Our Ref: KETRACO/ ST/007/2024

TENDER ADDENDUM AND CLARIFICATION No. 1 (TAC 1)

RE: EPC Construction for the pilot digital 400/132kV Makindu Substation (KETRACO/ST/007/2024)

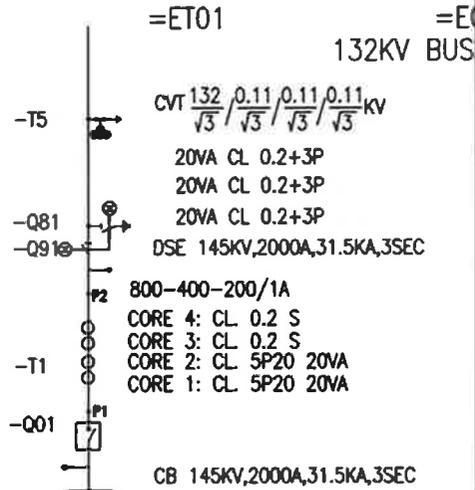
14	<p>Part 2 - Appendix A – TDS</p> <p>Drawings-SS-1_SLDs-KEY SLD-1_400 kV</p>	<p>3.8 420 kV CAPACITIVE VOLTAGE TRANSFORMER (METERING)</p> <table border="1"> <thead> <tr> <th>S.No.</th> <th>Description</th> <th>Unit</th> <th>Data Required</th> <th>Data Offered</th> </tr> </thead> <tbody> <tr> <td>1</td> <td>Manufacturer & Place of manufacturing</td> <td></td> <td></td> <td></td> </tr> <tr> <td>2</td> <td>Type</td> <td></td> <td>Capacitive</td> <td></td> </tr> <tr> <td>3</td> <td>Maximum permissible partial discharge level at 1Um</td> <td>pC</td> <td>10</td> <td></td> </tr> <tr> <td>4</td> <td>Maximum permissible partial discharge level at 1.2Um (V)</td> <td>pC</td> <td>5</td> <td></td> </tr> <tr> <td>5</td> <td>Method of suppressing Ferro resonance phenomena</td> <td></td> <td>RLC Damping</td> <td></td> </tr> <tr> <td>6</td> <td>Number of secondary s</td> <td></td> <td>2</td> <td></td> </tr> <tr> <td>7</td> <td>Rated voltage factor</td> <td></td> <td>1.5PU /3sec</td> <td></td> </tr> <tr> <td>8</td> <td>Rated transformation ratio</td> <td></td> <td></td> <td></td> </tr> <tr> <td></td> <td>Secondary I</td> <td>kV</td> <td>400/√3/11/√3</td> <td></td> </tr> <tr> <td></td> <td>Secondary II</td> <td>kV</td> <td>400/√3/11/√3</td> <td></td> </tr> <tr> <td>9</td> <td>Rated accuracy class</td> <td></td> <td></td> <td></td> </tr> <tr> <td></td> <td>Secondary I</td> <td></td> <td>0.2</td> <td></td> </tr> <tr> <td></td> <td>Secondary II</td> <td></td> <td>0.2</td> <td></td> </tr> <tr> <td>10</td> <td>Rated output (burden to be 25-100% rated burden)</td> <td></td> <td></td> <td></td> </tr> <tr> <td></td> <td>Secondary I</td> <td>VA</td> <td>50</td> <td></td> </tr> <tr> <td></td> <td>Secondary II</td> <td>VA</td> <td>50</td> <td></td> </tr> </tbody> </table> <p>SA 360KV,10KA,CLASS5 CVT 400/√3/0.11/√3/0.11/√3/0.11 Win1,2&3: CL3P/1.0-100VA CVT 400/√3/0.11/√3/0.11, Win1&2: CL0.2,50VA CT 4000-2000/1 A CORE 1: 0.2S 15VA CORE 2: 0.2S 15VA DSE 420KV,4000A,40KA,3SEC</p>	S.No.	Description	Unit	Data Required	Data Offered	1	Manufacturer & Place of manufacturing				2	Type		Capacitive		3	Maximum permissible partial discharge level at 1Um	pC	10		4	Maximum permissible partial discharge level at 1.2Um (V)	pC	5		5	Method of suppressing Ferro resonance phenomena		RLC Damping		6	Number of secondary s		2		7	Rated voltage factor		1.5PU /3sec		8	Rated transformation ratio					Secondary I	kV	400/√3/11/√3			Secondary II	kV	400/√3/11/√3		9	Rated accuracy class					Secondary I		0.2			Secondary II		0.2		10	Rated output (burden to be 25-100% rated burden)					Secondary I	VA	50			Secondary II	VA	50		<p>Correct VT ratio is</p> <p>400/√3/0.11/√3-0.11/√3 kV</p> <p>Specification and requirements as indicated in the Bid Document Part 2- Appendix A TDS clause 3.8 shall apply.</p> <p>Parameters for CVT2 in TDS are As shown on the diagram do not match the parameters on the 400kV SLD. Please confirm.</p>

Secondary I	VA	50																																																																																						
	Secondary II	VA	50																																																																																						
15	<p>The BOQ- PRICE SCHEDULES- Makindu BOQ-SS</p>	<p>Schedule 1_SS</p> <table border="1"> <tr> <td>1:13</td> <td>Capacitive voltage transformer - (Protection & Measuring, 1-phase) Supply will be based on TDS and description. All accessories will be included to make testing and commissioning completed. Phase summation galvanised junction box will be provided</td> <td>No.</td> <td>20</td> </tr> </table>	1:13	Capacitive voltage transformer - (Protection & Measuring, 1-phase) Supply will be based on TDS and description. All accessories will be included to make testing and commissioning completed. Phase summation galvanised junction box will be provided	No.	20	<p>The number of CVTs in the BOQ table does not match the number on the 400 kV SLD. The BOQ indicates 20 while the 400kV SLD indicates 18. Please clarify.</p>	<p>The numbers as indicated in the BOQ are correct and are in line with SLD.</p>

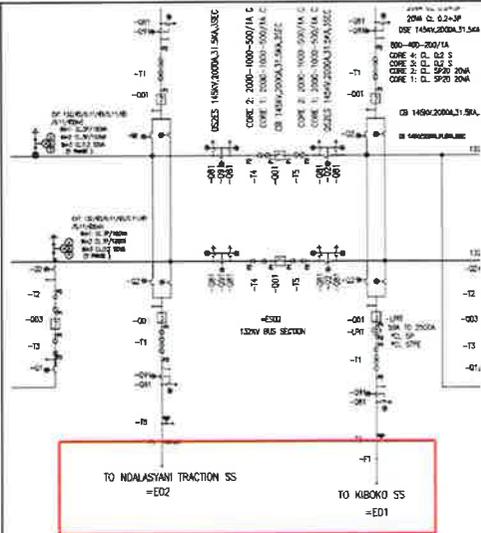
83																																		
84	2.17	132kV Capacitive voltage Transformer of Protection & Measuring (1-phase, three cores) for 132kV busbar, All accessories will be included to make testing and commissioning completed.	No	4																														
85																																		
18	The BOQ- PRICE SCHEDULES- Makindu BOQ-SS	<p>Schedule 1_SS</p> <table border="1"> <tr> <td>65</td> <td></td> <td></td> <td></td> <td></td> </tr> <tr> <td>66</td> <td>2.8</td> <td>Surge arrester (1-phase) including surge counter with earth leakage meter connecting to earth greed All accessories will be included to make testing and commissioning completed.</td> <td>No.</td> <td>12</td> </tr> <tr> <td>67</td> <td></td> <td></td> <td></td> <td></td> </tr> </table>	65					66	2.8	Surge arrester (1-phase) including surge counter with earth leakage meter connecting to earth greed All accessories will be included to make testing and commissioning completed.	No.	12	67					The number of Surge Arresters in the BOQ table does not match the number on the132 kV SLD (12 in the BOQ and 6 in the the132 kV SLD). Please clarify.	The numbers as indicated in the BOQ are correct and are in line with SLD. 6 Nos 132kV Surge arresters shown in Sheet 2/3 ,DWG NO:SL61MKD=A000

65																																		
66	2.8	Surge arrester (1-phase) including surge counter with earth leakage meter connecting to earth greed All accessories will be included to make testing and commissioning completed.	No.	12																														
67																																		
19	Part 2 - Appendix A – TDS Drawings-SS-1_SLDs-KEY SLD-2_132kV	<p>4.12 132 kV LOW POWER INSTRUMENT TRANSFORMER LPIT –OIL FEEDER</p> <table border="1"> <thead> <tr> <th>S.No</th> <th>Description</th> <th>Unit</th> <th>Data Required</th> <th>Data Offered</th> </tr> </thead> <tbody> <tr> <td>1</td> <td>Manufacturer</td> <td>-</td> <td>Optical output</td> <td>14500</td> </tr> <tr> <td>2</td> <td>Make</td> <td>-</td> <td>-</td> <td>-</td> </tr> <tr> <td>3</td> <td>Rated current</td> <td>A</td> <td>up to 4000</td> <td>-</td> </tr> <tr> <td>4</td> <td>Short-circuit current capability (1 s)</td> <td>kA</td> <td>63</td> <td>-</td> </tr> <tr> <td>5</td> <td>Accuracy class</td> <td>-</td> <td>IEC 71, IECB 0.7%</td> <td>-</td> </tr> </tbody> </table>	S.No	Description	Unit	Data Required	Data Offered	1	Manufacturer	-	Optical output	14500	2	Make	-	-	-	3	Rated current	A	up to 4000	-	4	Short-circuit current capability (1 s)	kA	63	-	5	Accuracy class	-	IEC 71, IECB 0.7%	-	Parameters for LPIT in TDS are As shown on the diagram do not match the parameters on the 132 kV SLD. Please clarify.	Optical sensor offers a wider operating range in comparison with conventional CTs, depending on the manufacturer it might be from 1-4000A or 50-2500A, in this case both are fulfilling the requirements. For clarity use a minimum requirement as 50-2500A, Class 5P/5PTE Refer to Bid document Part 2 Appendix-A-TDS section 4.12
